**Summary of Errata and Clarifications to the HDCP Interface
Independent Adaptation Specification Rev 2.1**

Figure 2.6. Upstream Propagation of Topology Information

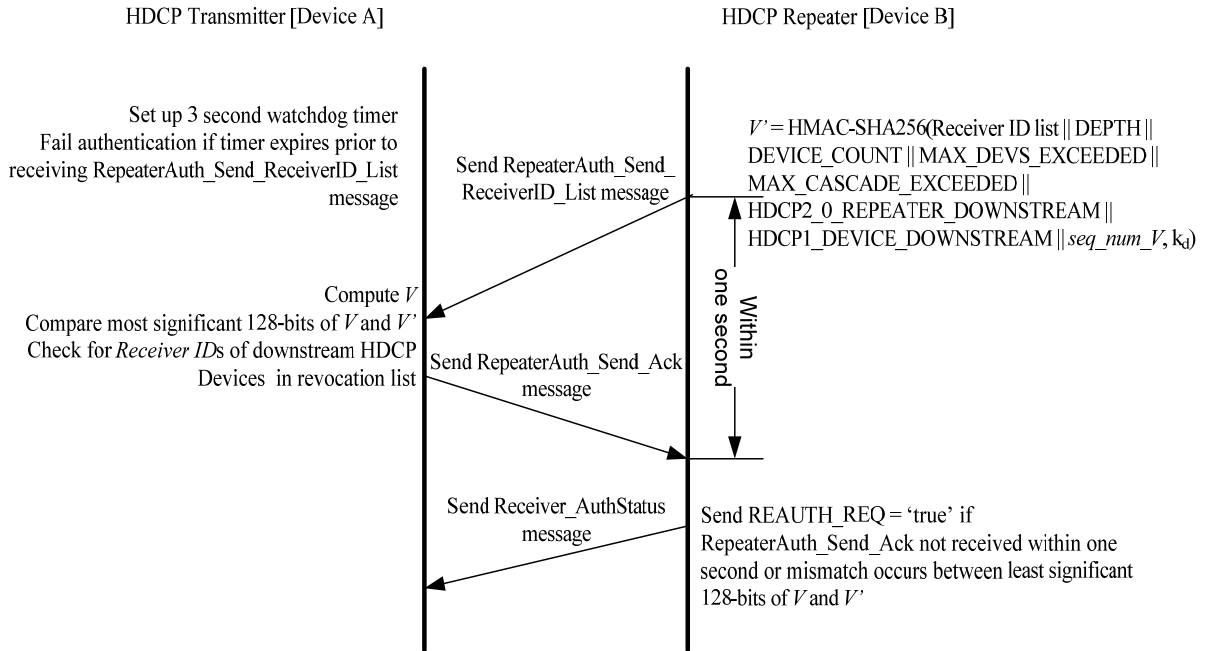
Page 20, Section 2.5.1, replace Figure 2.6 with the following
